RE: Safety Assessment of Municipal Pool

Pursuant to your request, what follows are recommendations resulting from our expedited risk management review of the Lower Makefield Township Municipal Pool conducted earlier today. At the time of the assessment, we were accompanied by Mr. Wes Sheffer, Pool Manager and Ms. Lynne Todd, Pool Operations Manager. I have compiled the recommendations using DVT's standard risk management recommendation format.

Priority: B Pool – Kiddie Pool Perimeter Fence

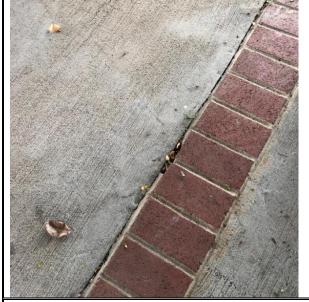
It is recommended that Lower Makefield chain closed the unsecured gate leading from the kiddie pool area to the picnic pavilion area.
